# CITY OF ALBUQUERQUE

**RE: 752 Menaul Blvd NW**  
**Grading and Drainage Plan**  
**Engineer's Stamp Date: 12/19/23**  
**Hydrology File: H14D119**

ENGINEER'S SEAL	752 MENAUL BLVD GRADING AND DRAINAGE PLAN	DRAWN BY DEM
DAVID SOULE NEW MEXICO REGISTERED PROFESSIONAL ENGINEER 14522		DATE 12-16-23
12/19/23	 Rio Grande Engineering P.O. BOX 53924 ALBUQUERQUE, NM 87199 (505) 321-9099	752 Menaul Blvd.DWG
DAVID SOULE P.E. #14522		SHEET # C1
		JOB #

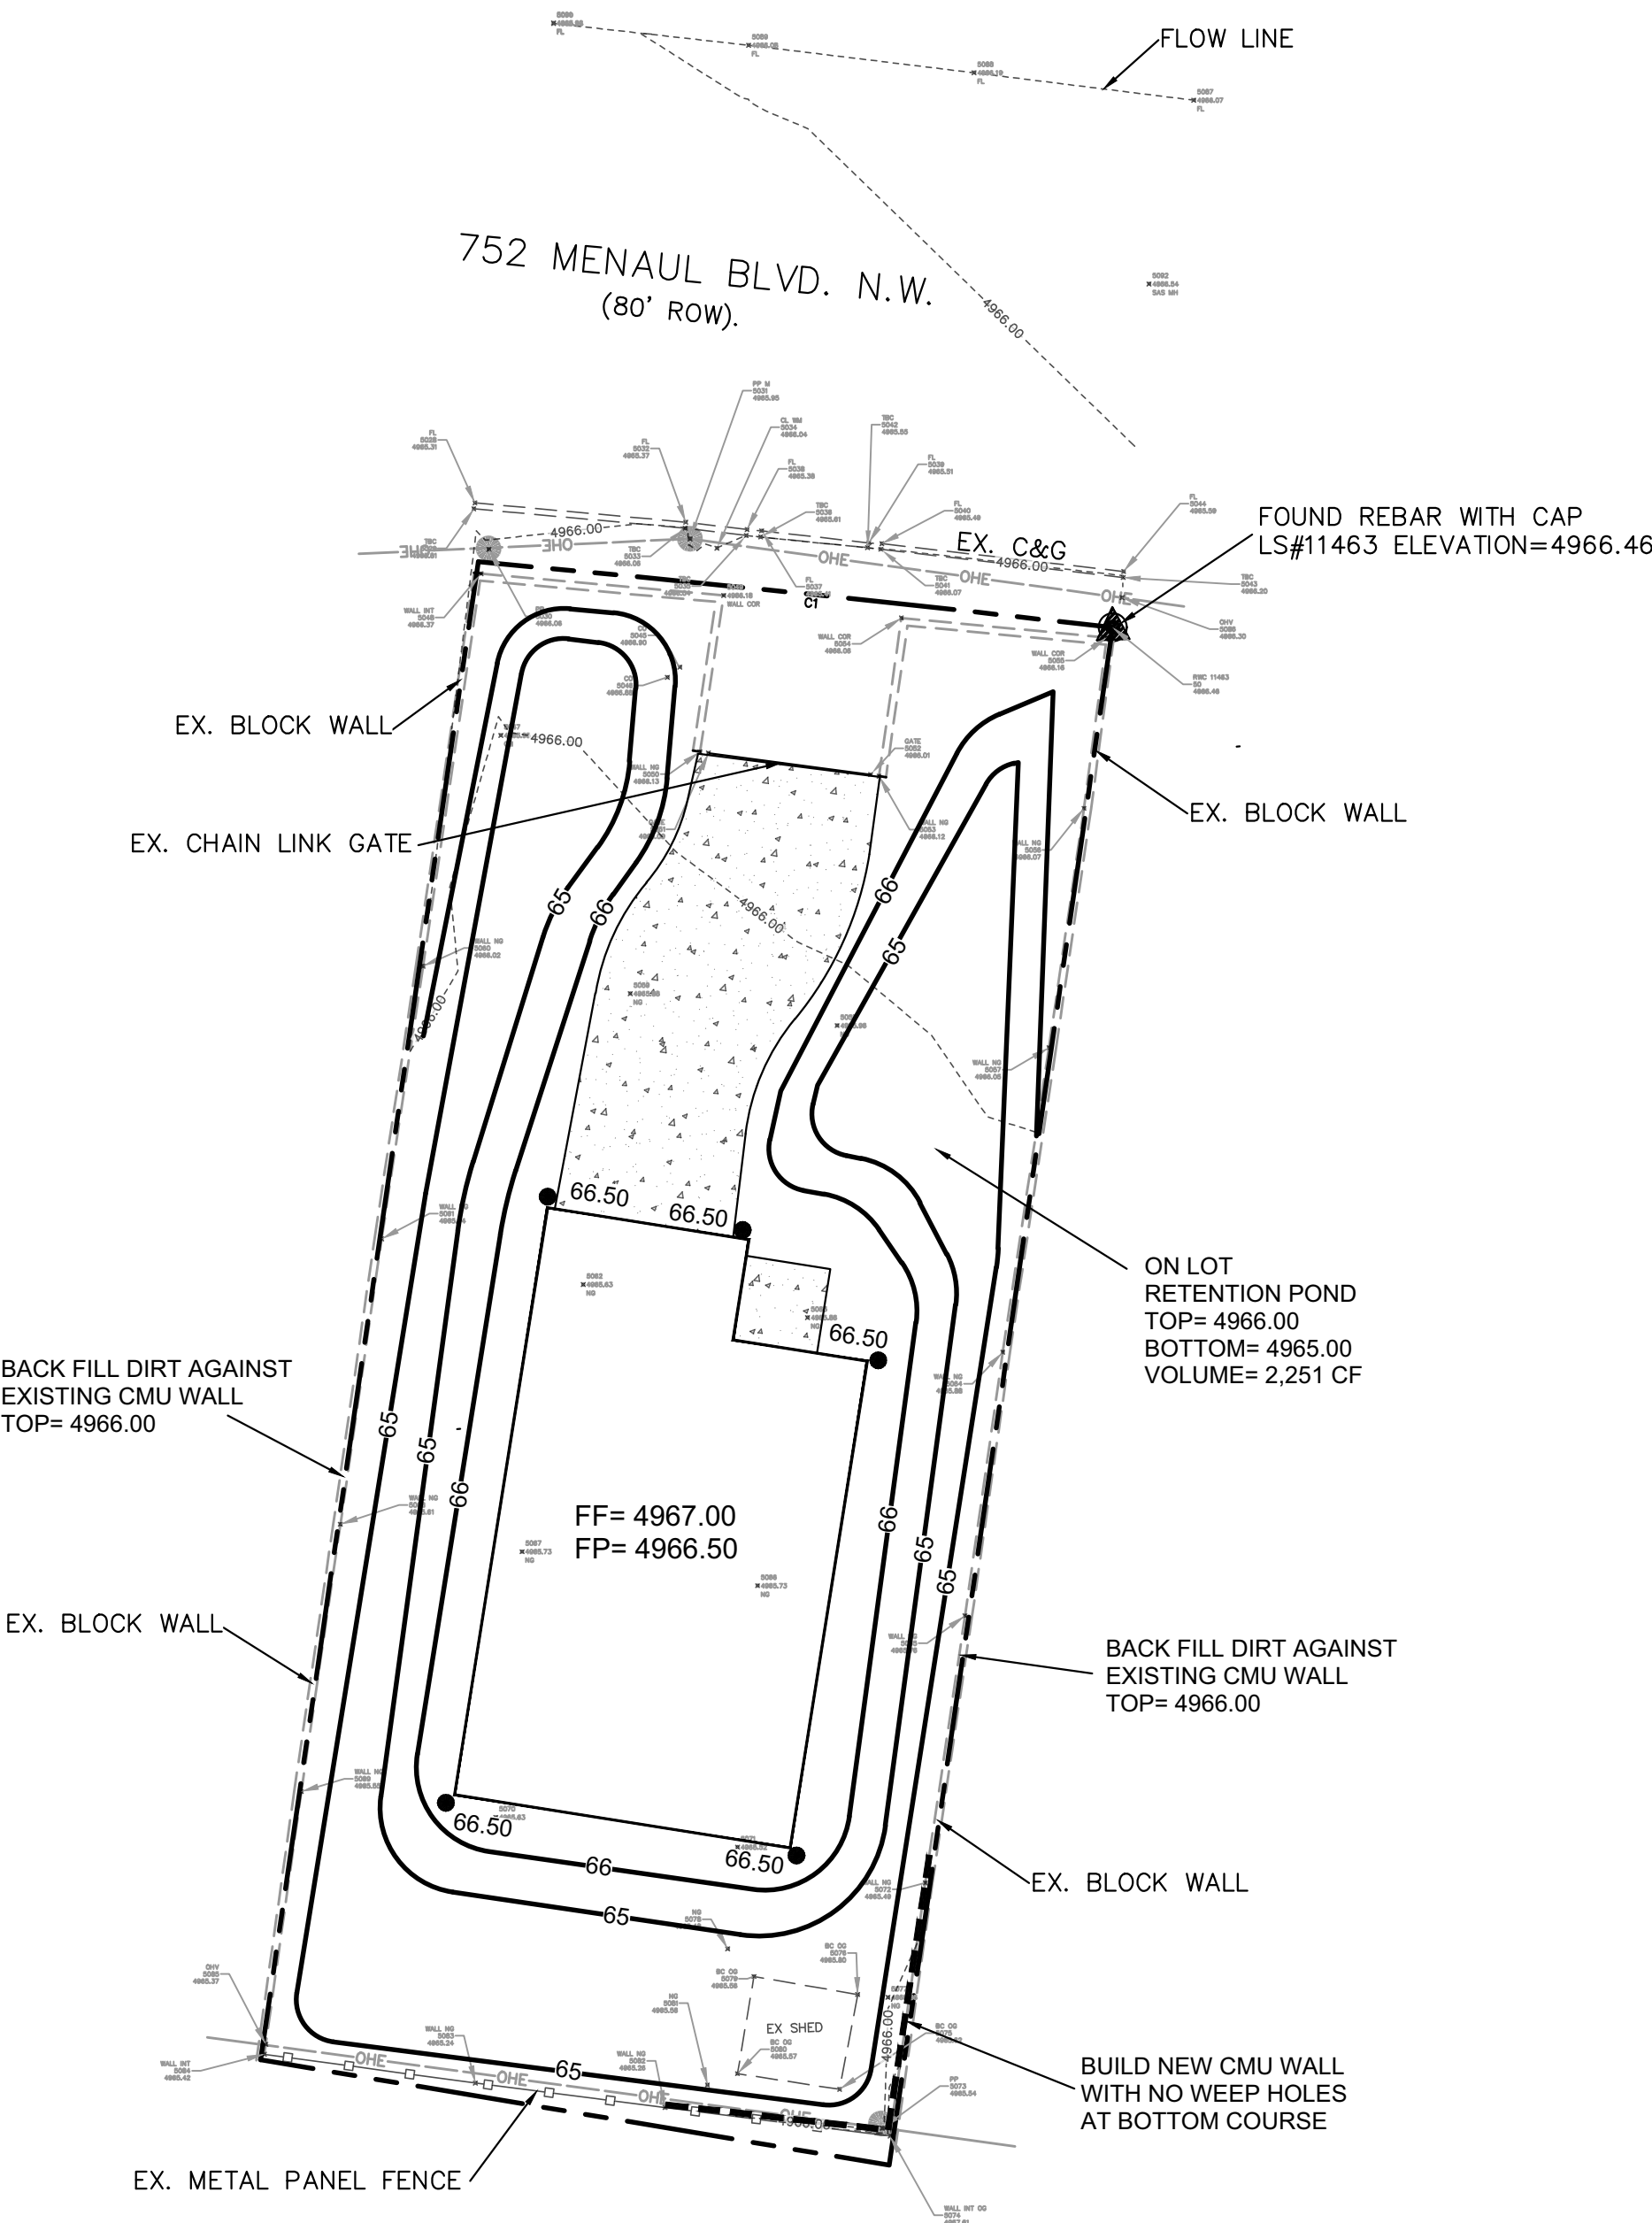
Based upon the information provided in your submittal received 12/19/2023, the Grading and Drainage Plan is approved for Building Permit and Grading Permit. **Since this site is relatively flat, a pad certification is not needed for this project.** Please attach a copy of this approved plan in the construction sets for Building Permit processing along with a copy of this letter.

1. Engineer's Certification, per the DPM Part 6-14 (F): Engineer's Certification Checklist For Non-Subdivision is required.
